GERALD R. FORD INTERNATIONAL AIRPORT

**TAXIWAY F & G RECONSTRUCTION (NORTH OF TAXIWAY V, 1,950' X 35');
TAXIWAY F & G AIRFIELD LIGHTING REPLACE**

PROJECT NUMBER C-435

ADDENDUM #1

A1 TYPICAL PERIMETER ROAD PAVEMENT SECTION (ADD ON NO.1)
SCALE: NOT TO SCALE

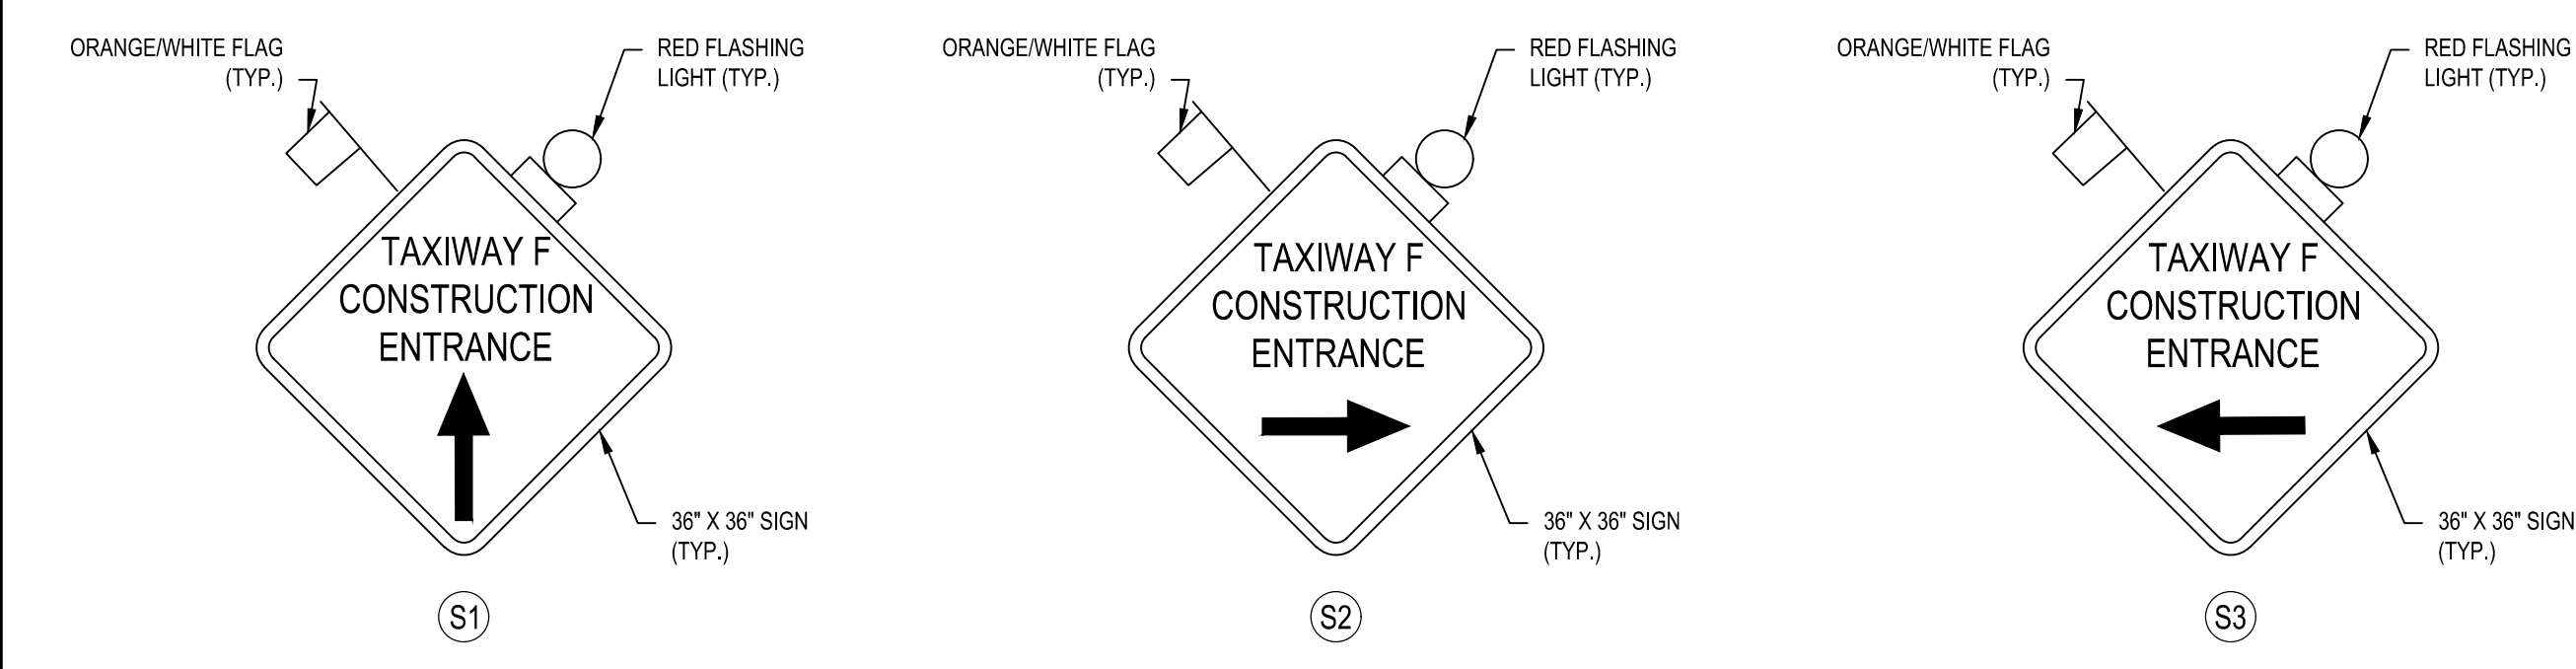
- A: The requirement for ALCMS graphics modifications has been deleted from the scope of work. Sheet E202 and Spec L-109 have been updated.
- Q: Plan page GC501 shows paving the perimeter road Pavement section with 2" of 4EML as part of safety and security. Why couldn't this be paid as a Syd or Ton item?

- A: The item has been updated and broken off as an add-on. Please see revised sheets attached to this addendum.
- Q: Are airfield low profile barricade available from the airports stock of barricades for the project?

29. EXISTING ASPHALT ROADWAY SHALL BE REPAIRED FOLLOWING COMPLETION OF SPOILING AND HAULING OPERATIONS. THE EXISTING PAVEMENT HAS FAILED AND HAS BEEN BACKFILLED WITH APPROXIMATELY 8 INCHES OF ASPHALT MILLINGS TO MAINTAIN STRUCTURAL INTEGRITY. SEE DETAIL A1/GC501. (ADD ON NO.1)

A1 CONSTRUCTION SAFETY AND PHASING PLAN - SPOILS AND BATCH PLANT ACCESS

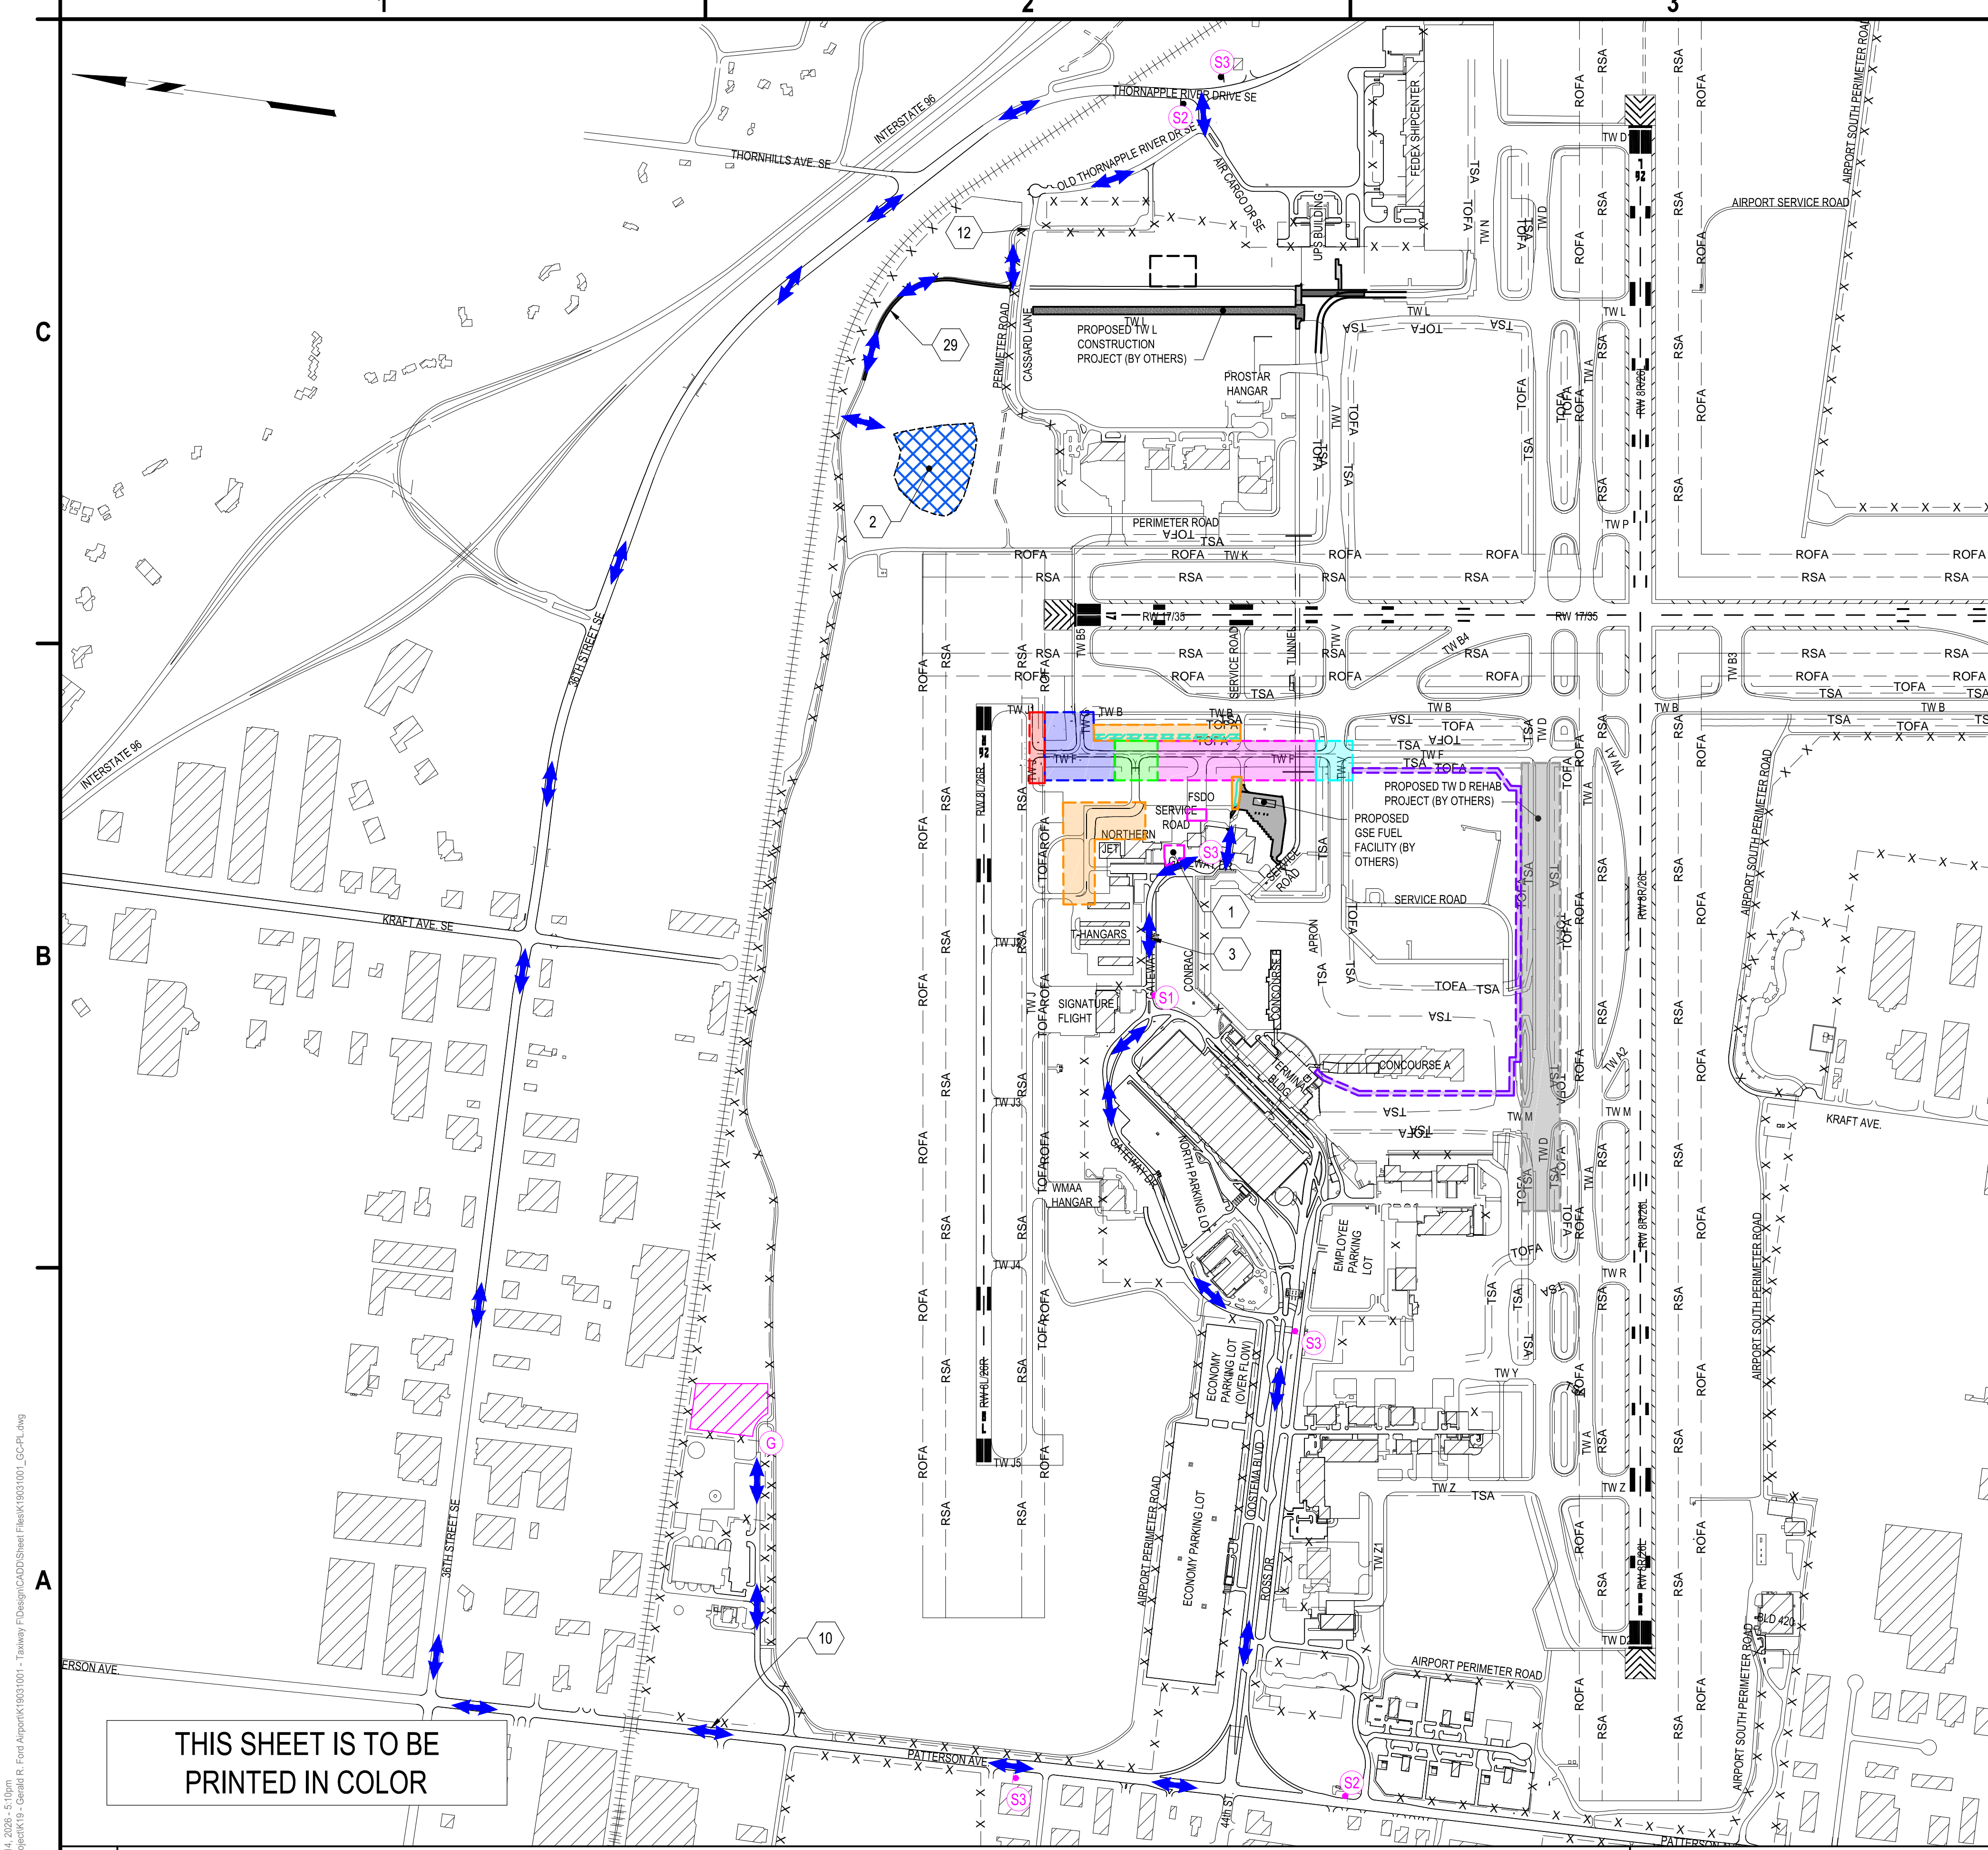
- A: Clarification on material to be spoiled has been provided. See revised sheet GI003 attached to this addendum.
- Q: Can a breakdown of the P209 item be provided? The item includes 1800 cods of possible undercut. I cannot find get to the plan quantity with the area that is full reconstruct and the undercut budget.

33. THE QUANTITY OF UNCLASSIFIED EXCAVATION (SPOILED ON-SITE), ITEM P-152, INCLUDES 1,100CY OF EXCAVATION FOR SLAG BASE MATERIAL WITH CEMENT TO BE SPOILED ON-SITE. MATERIAL TO BE SPOILED ON-SITE SHALL BE DISPOSED OF IN THE LOCATION AS SHOWN ON THE PLAN SHEETS AND SHALL ONLY BE USED AS DIRECTED BY THE AIRPORT OWNER

1 AIRFIELD LIGHTING ELECTRICAL VAULT PROPOSED PLAN
 E201 SCALE: N.T.S

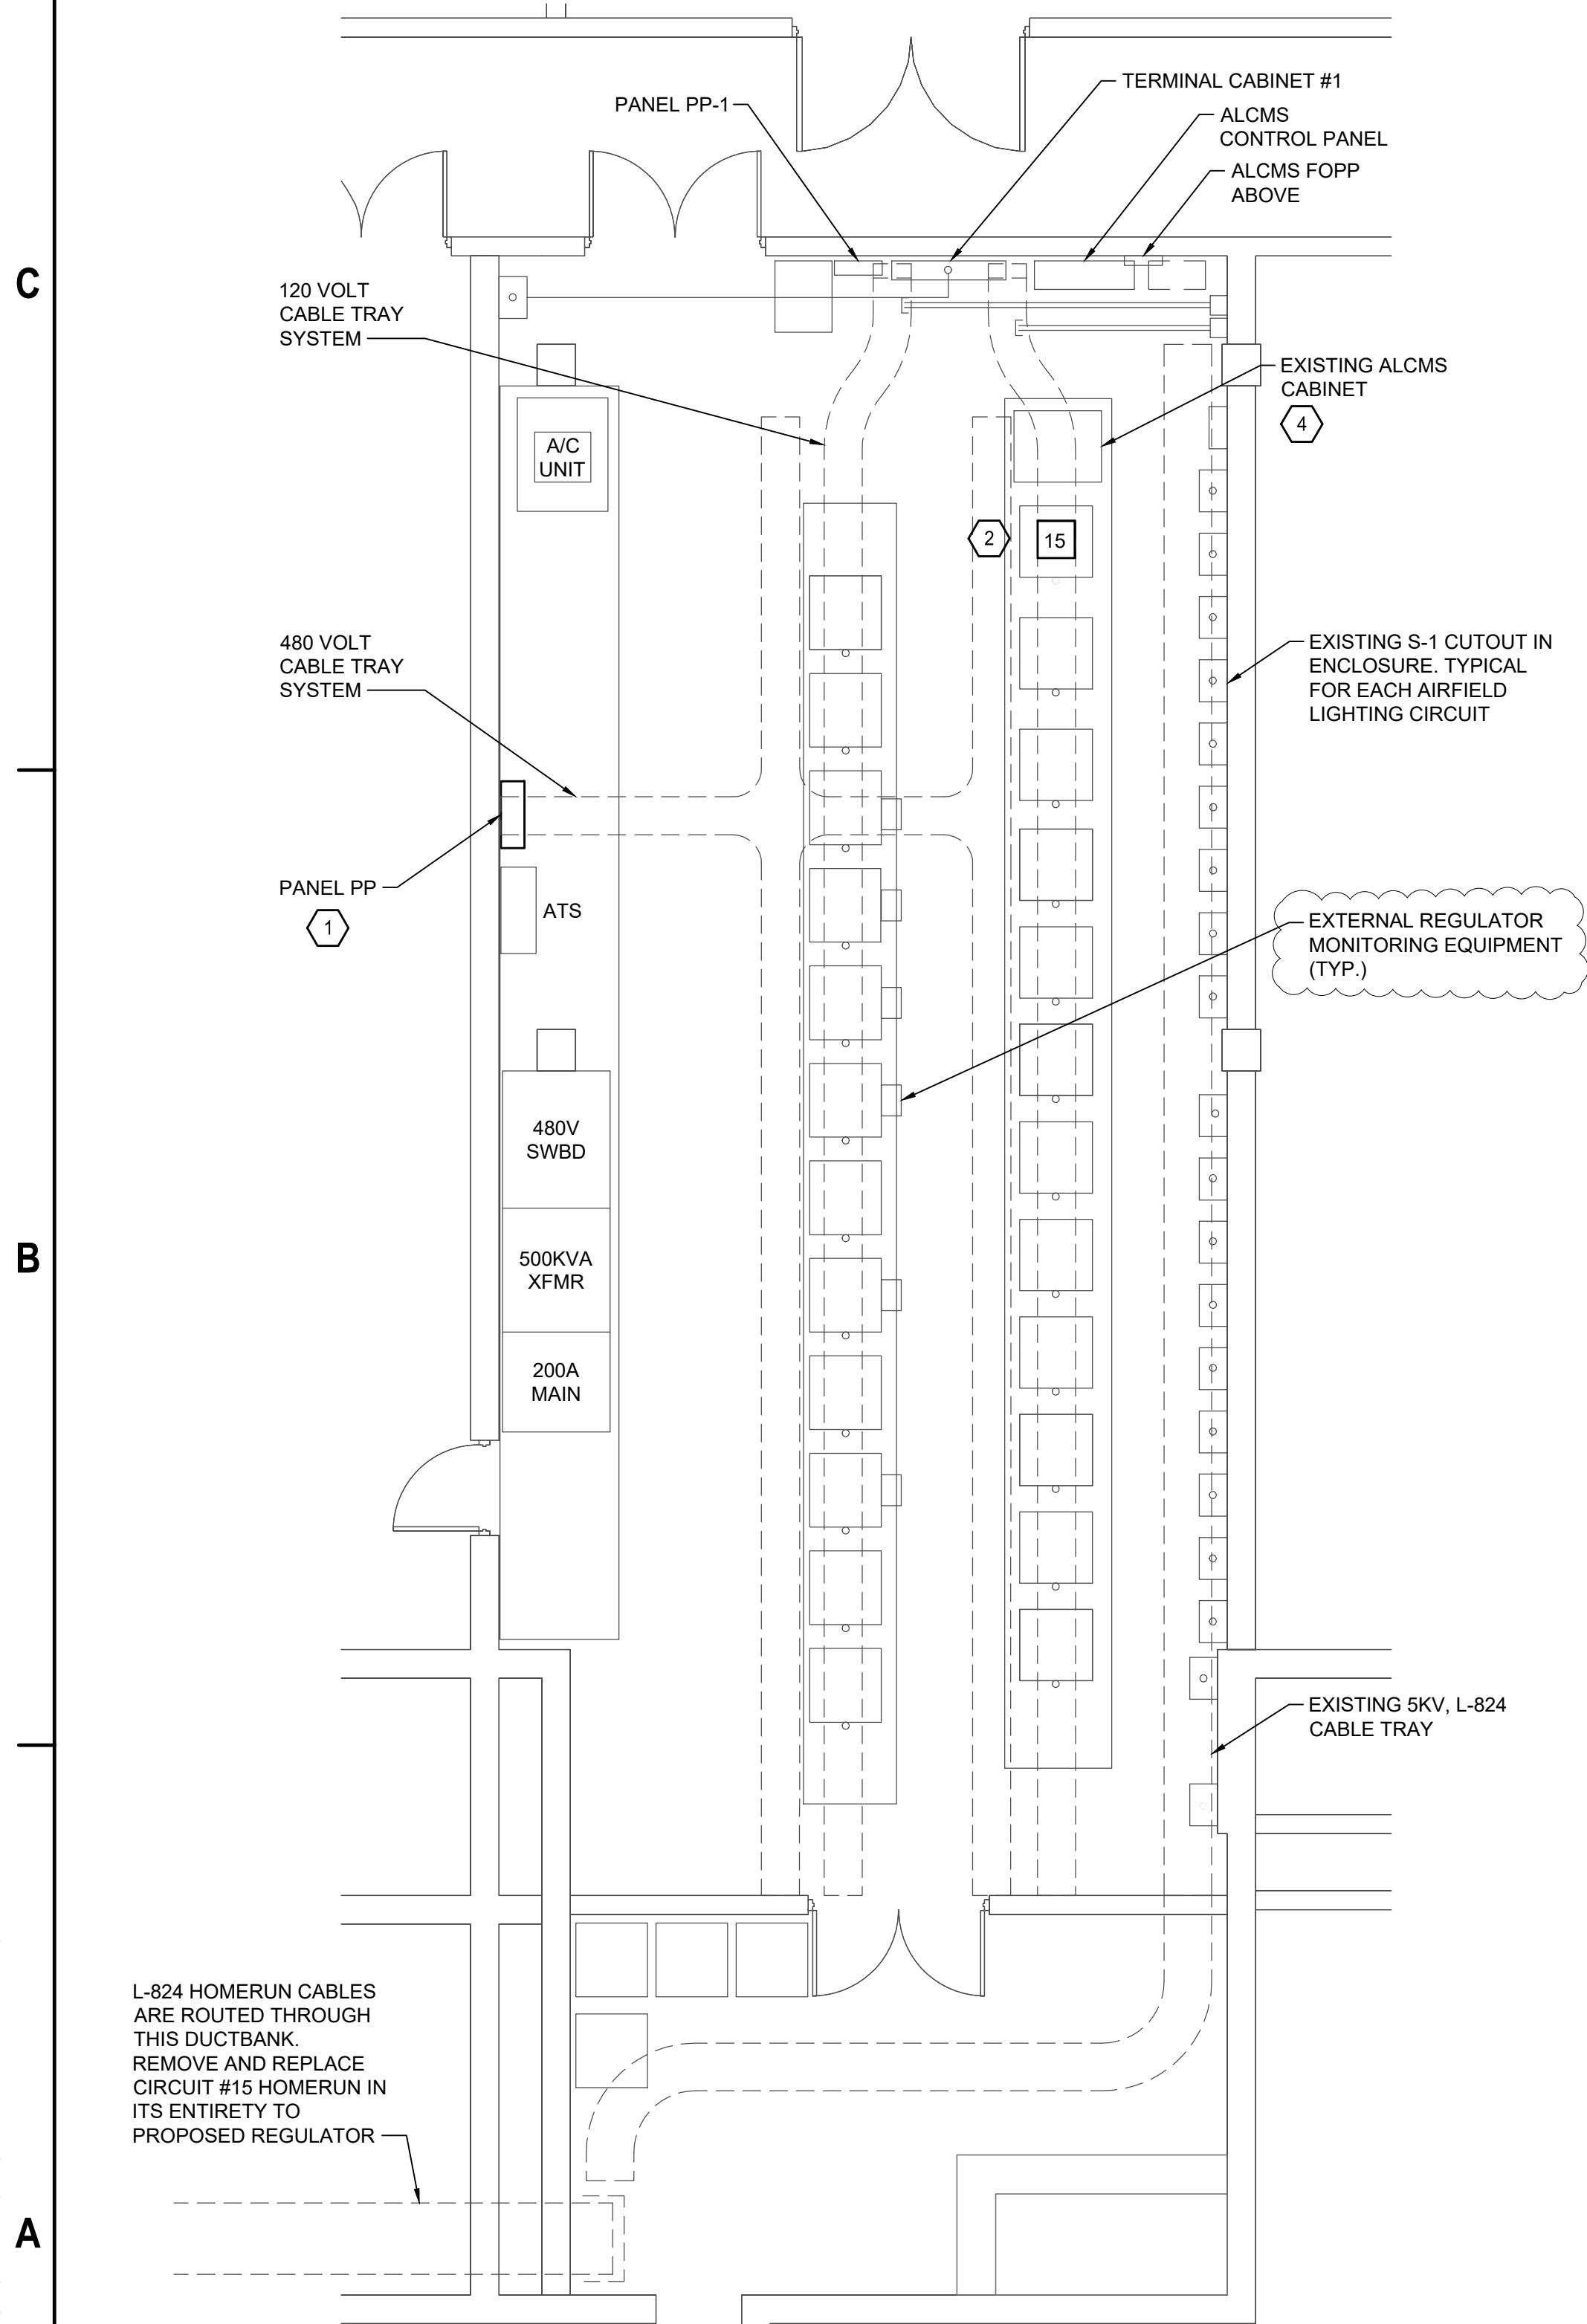
- Q: Can the references to brand name or equal, and the requirement for an ACE3 unit please be removed from E202 per AIP Handbook table U-4 (2) *Brand Name or Equal: If an existing FAA technical specification establishes all necessary performance requirements, the FAA considers the use of a brand name or equal to be a restriction on competition. A sponsor must not disqualify a material, product, or service for not having a characteristic that the brand name material, product, or service possesses if the characteristic was not explicitly identified in the technical requirements.*

- A: Both items have been deleted; Sheet E202 has been updated.
- Q: The project also includes ALCMS modifications as noted in 109-1.1, and E202 Keyed Note 4 *EXISTING ALCMS SYSTEM SHALL BE MODIFIED TO SHOW NEW TW F&G GEOMETRY ON ALL SCREENS. EXISTING CCR CONTROL TO BE TIED TO NEW CCR.* All hardware/software/interface & controls/components are proprietary/sole source to the control system and will need to be procured outside of this AIP Funded Project per AIP Guidelines, AIP

Handbook 5100-38D Change 1, 3-36 Limited Noncompetitive Proposal Situations (ALCMS Modifications...). Please verify this is being procured outside of the AIP funded project.
